55105AMOD - Modified Source Body for **Varian E500 Implanters**

Glemco presents an optimized E500 Source Body, that eliminates misalignment when used with the modified Source Flange 55327A. The new interface between the customized source body and flange, provides precise positioning.

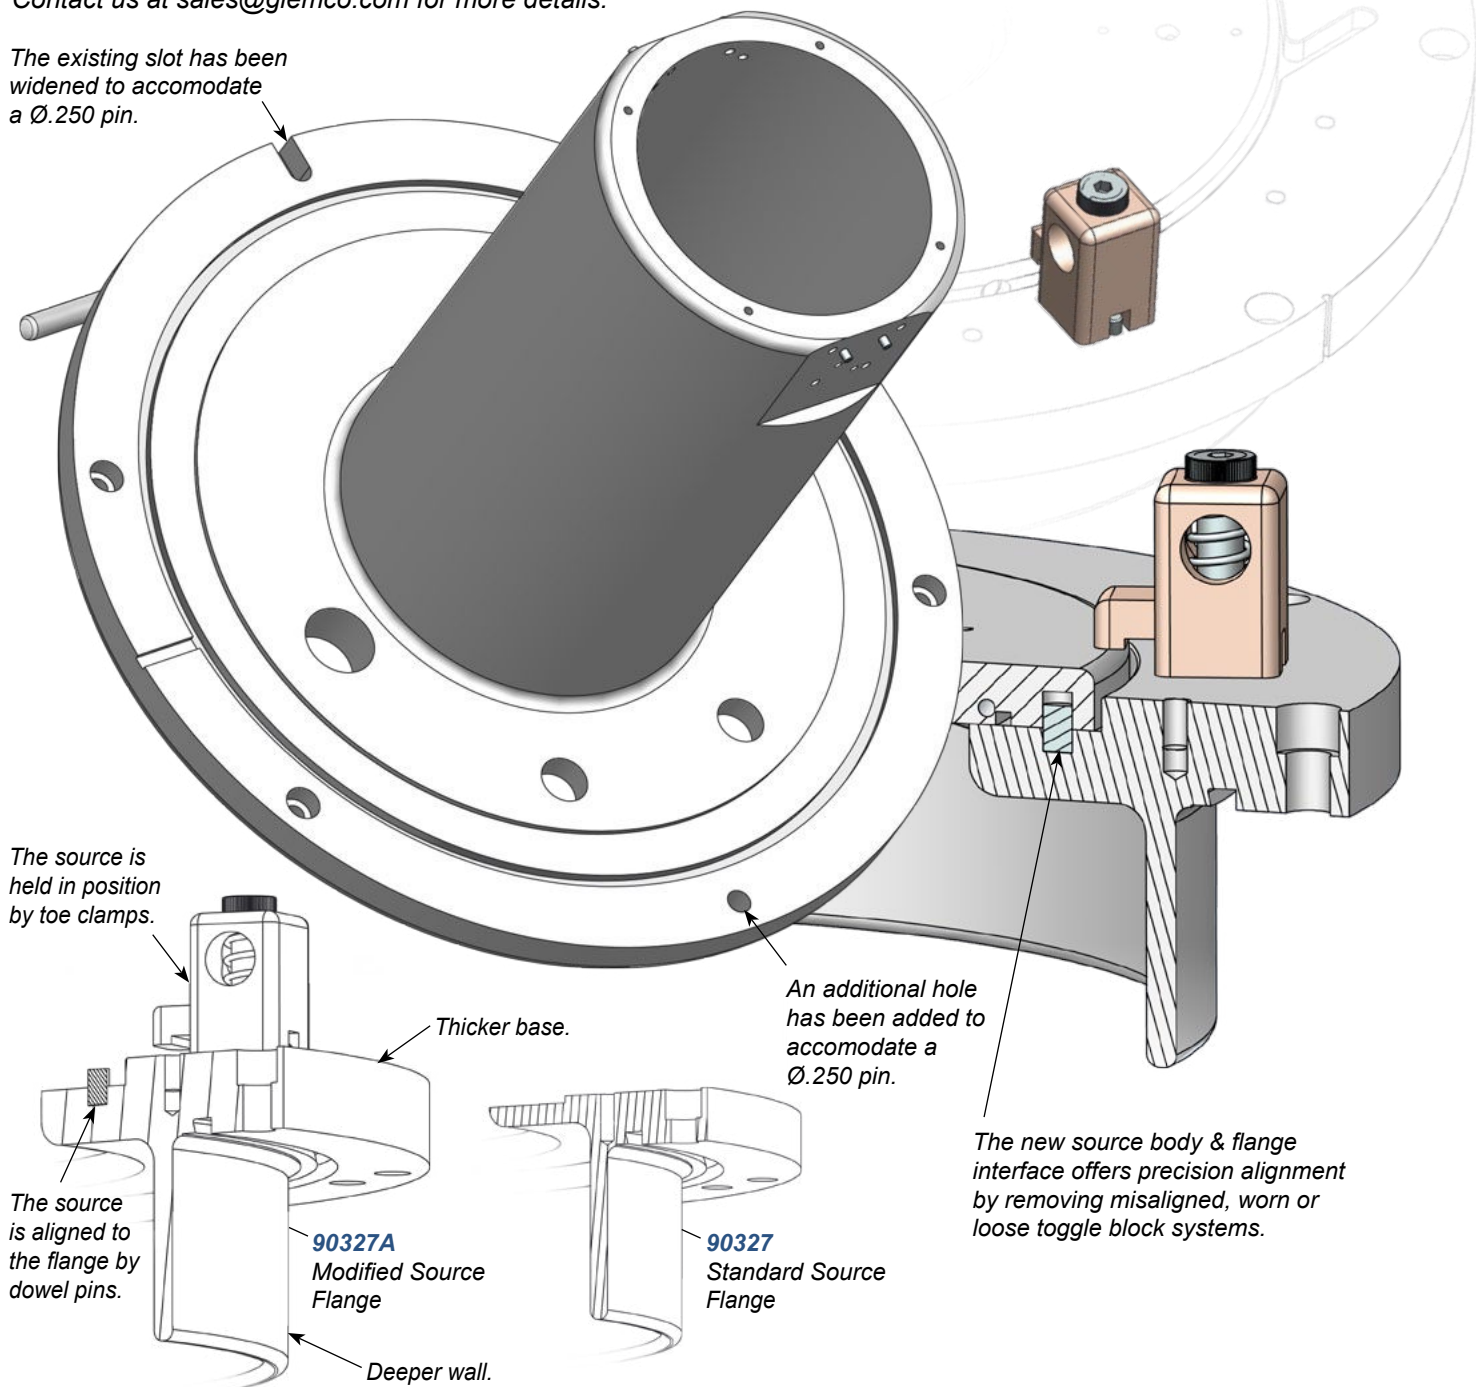
The existing slot has been widened to accommodate a Ø.250 pin.
